STAFF RECOMMENDATION

NCPC File No. 6611

FEDERAL OFFICE BUILDING 8 BUILDING MODERNIZATION 200 C Street, SW Washington, DC

September 27, 2007

Aerial View of 2nd and C Streets (Above); Perimeter Security & Landscape Plan (Below)

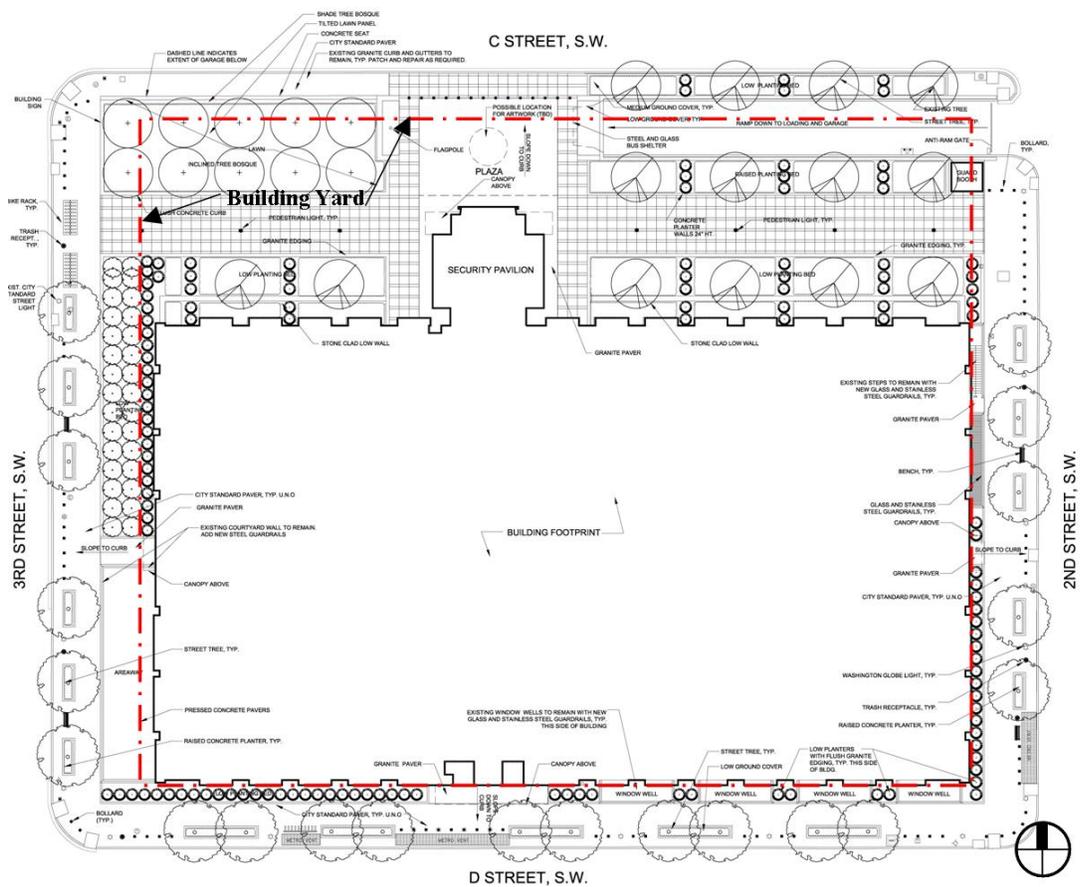
The deep setback on the building’s C Street front is characteristic of its modernist origins and is shared by three of the four buildings intersecting at 3rd and C Streets. Part of the assessment of the building’s significance and character-defining features will involve an assessment of its setting, including the characteristic setback of a building of this era on its site. As proposed, the security screening pavilion on the C Street facade as well as the lines of bollards and planters and at the sidewalk curb surrounding the building on all four sides would project beyond the building wall envelope into space intended for use as a public plaza and into other public space under the jurisdiction of the District of Columbia government.

Staff believes that the setback is a characteristic setting from the modernist era and expresses concern that the screening pavilion should be designed to take into consideration the views out across the plaza's setback and along C Street. Although the plaza is not within the L'Enfant rights-of-way, GSA intends for it to function as public space in that it will serve as a public plaza for employees, visitors, and other pedestrians. NCPC's Urban Design and Security Objectives and Policies of May 5, 2005 encourage building additions for pedestrian screening operations to be compatible with existing architecture and not project into L'Enfant Plan rights-of-way, other public space, or view-sheds; and also encourage that perimeter security be kept within the building yard.

Comments unfavorably on the perimeter security design because the perimeter barrier system intrudes into the public right-of-way on all four sides of the building and **comments unfavorably** on the security screening pavilion proposed for the building yard because the pavilion addition pushes the front of the building 48 feet further north and therefore pushes the perimeter security

line into public space, and **requires** GSA to submit an analysis of the level of security required in accordance with NCPC’s Urban Design and Security Objectives and Policies adopted May 5, 2005 and related submission guidelines.

Rendered View at 3rd and C Streets; North and West Faces

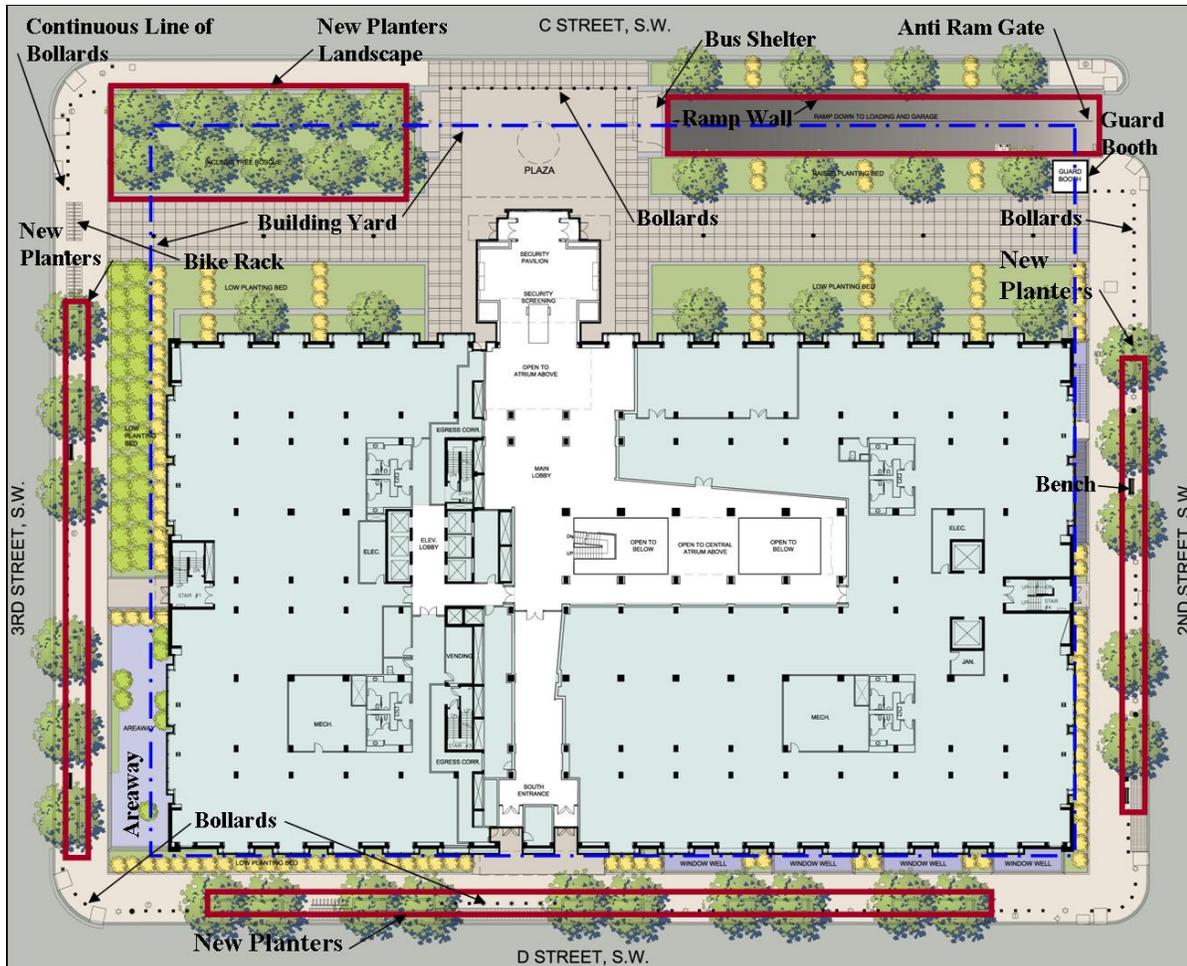
NCPC Urban Design and Security Objectives and Policies adopted May 5, 2005 state that building additions to accommodate pedestrian screening security operations should be compatible with existing architecture and not project into L'Enfant Plan rights-of-way, other public space, or viewsheds. The proposed addition projects beyond the building envelope into the site's setback, which the applicant proposes to use as public space.

While staff acknowledges the validity of emphasizing the existing understated building entrance by making it more visible, staff recommends that the proposed two-story security pavilion with battered glass and granite walls and angled glass ceiling adds significantly more bulk than needed to create a legible entrance. If the screening pavilion remains, staff recommends that the applicant reduce its size to minimize impact to the public plaza.

Requires that the applicant reduce the size and mass of the security screening pavilion to minimize impact to building’s setting if the screening pavilion remains a part of the project.

In-Progress Master Plan Concept for 3rd and C Streets, SW

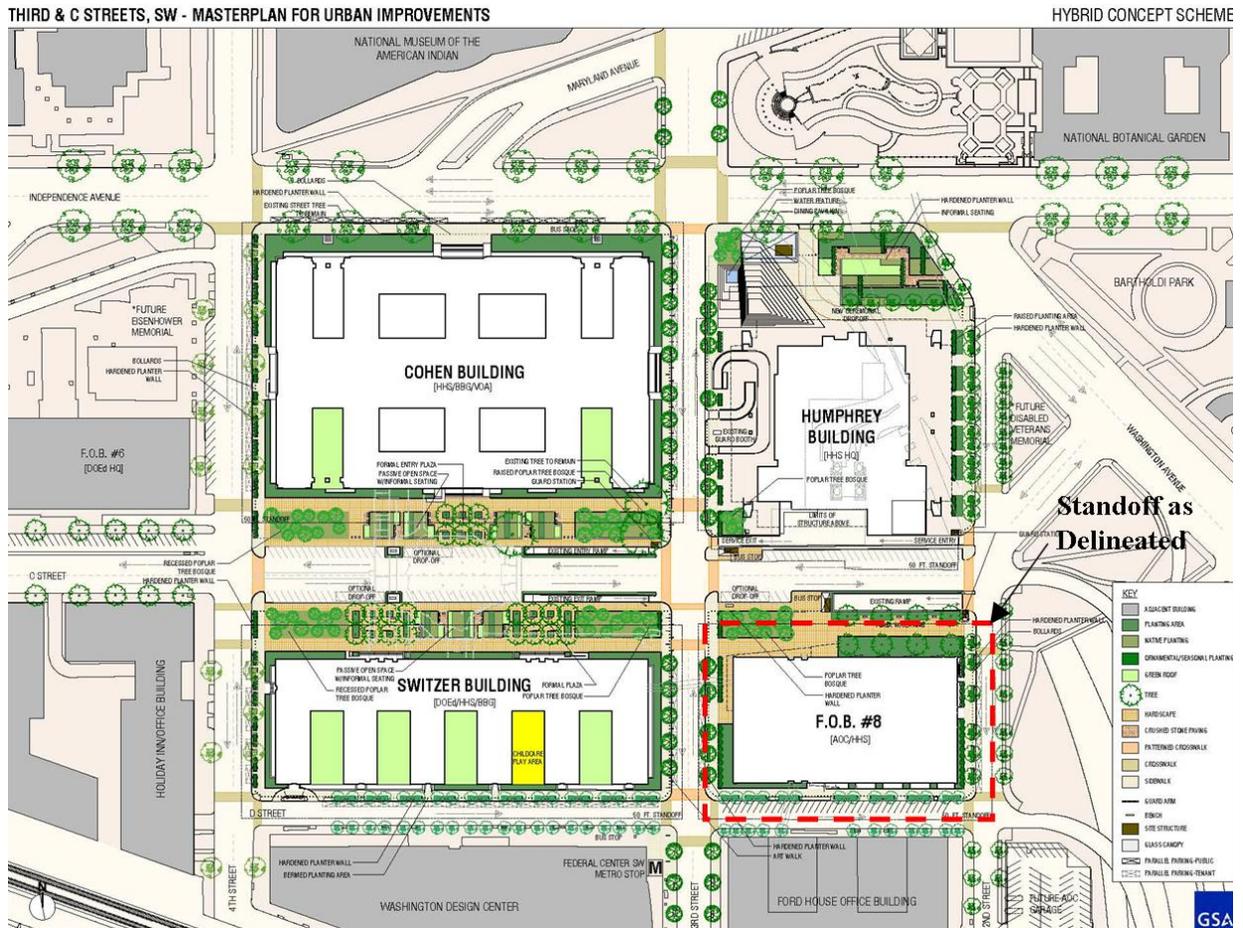
The front building set back depth would also enable the applicants to achieve the stated security level and required building standoff, which is delineated by a dashed line on the Third and C Streets, SW Master Plan for Urban Improvements “Hybrid Concept Scheme” (HCS), enclosed for reference. However, the barrier line proposed on the FOB 8 site plan is shown outside the standoff as delineated on the HCS, and outside of the building yard, within the L'Enfant right-of-way. Staff recommends that the applicant consult with NCPC staff and DDOT's Office of Public Space in developing perimeter security that respects the public space and L'Enfant rights-of-way for FOB 8. Staff reminds the applicant to consult on public space impacts of the Third and C Streets SW Master Plan for Urban Improvements with DDOT's Public Space Committee Requires and submit

Although the applicant has not submitted its Third and C Streets, SW Master Plan for Urban Improvements for NCPC review and approval, GSA has included the Hybrid Concept Scheme" (HCS) showing its progress, for reference with this submittal of FOB 8. The HCS delineates bollard lines, often outside of standoff distances shown for the FOB 8 and the three buildings that share the intersection with it. (Three of the four buildings have the same deep setbacks from C Street, allowing them to meet standoffs as delineated on the plan). The set back depth on C Street would enable achieving the stated security level and required building standoff, shown delineated by a dashed line on the HCS. However, the bollard line as proposed on the FOB 8 site plan is outside the standoff delineated on the HCS, as well as outside of the building yard, within the L'Enfant right-of-way. Because GSA indicates that it will further develop the master plan for this area, staff reiterates that the applicant should submit the Master Plan to NCPC for review and approval prior to submitting the preliminary phase of this project to resolve discrepancies.

Requires that GSA submit its Third and C Streets Southwest Master Plan for Urban Improvements for NCPC review and approval prior to submitting the preliminary phase of this project.

the Master Plan Improvements to NCPC for review and approval prior to submitting the preliminary phase of this project to resolve discrepancies.
